I M G-Golder Corporation

June 28, 2002

RE: Response to DFO Comments on the Proposed Acoustic and Fish Monitoring Program

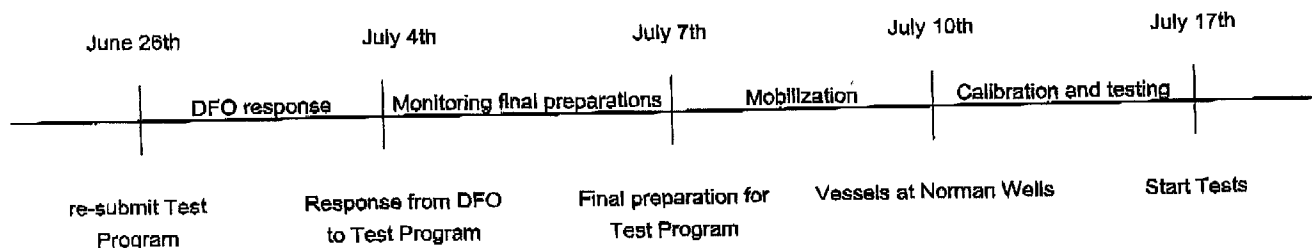
22. A varying number of hydrophones will be used in the acoustic test program. This number is water depth, and channels available dependant. It must be noted that WesternGeco sees great value in the results of the acoustic test program and will be putting a lot of resources including time and money into obtaining good quality measurements.

One of the criteria for doing the acoustic measuring will be a change in the geology. This change would be noted by, amongst other factors, a change in the reflection of the seismic signal during acquisition. WesternGeco disagrees that the test positions should be included on a map during the project submission. This would in fact limit WesternGeco's ability to obtaining results only in predefined areas, and not necessarily the most valuable areas.
